Office Action Summary

10/599,455

SAKAI ET AL.

DETAILED ACTION'

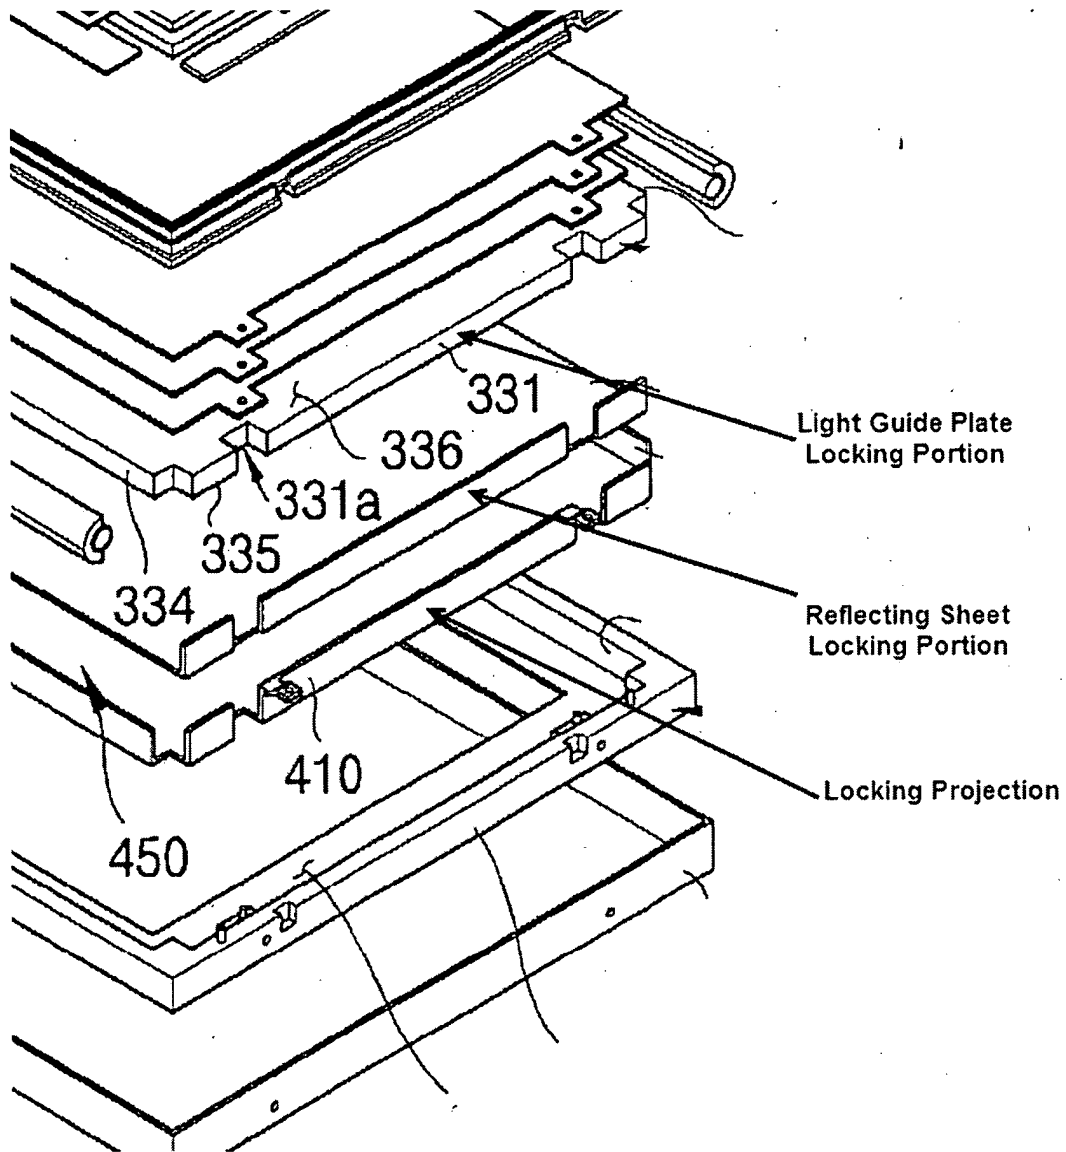
Regarding Claim 1, Lee discloses in Figure 1, a lighting unit comprising a housing 400, 500 having a rectangular bottom wall, wherein a locking projection (vertical side tab extending from the bottom wall of chassis 400 as shown in the annotated figure) that projects from said bottom wall is formed respectively at a pair of facing side edges of the housing; a reflection sheet 350 that has locking portions (as shown in the annotated figure) that lock with said locking projections, a light guide plate 330 that is laminated over said reflection sheet and has locking portions (as shown in the annotated figure) that lock with said locking projections, and light sources 310 deployed at both ends of said light guide plate 330 and wherein said locking projections are formed on the center line that connects the center points of those of said light guide plate's edges on which no light source is deployed.

Regarding Claim 2, Lee discloses in Figure 1, said locking projections are linear projections of a particular length that are parallel to the facing side edges.

Regarding Claim 5, Lee discloses in Figure 1, the liquid crystal display comprising the lighting unit according to claims 1 and further comprising a liquid crystal panel 210 that is located on the irradiating surface side of said lighting unit.
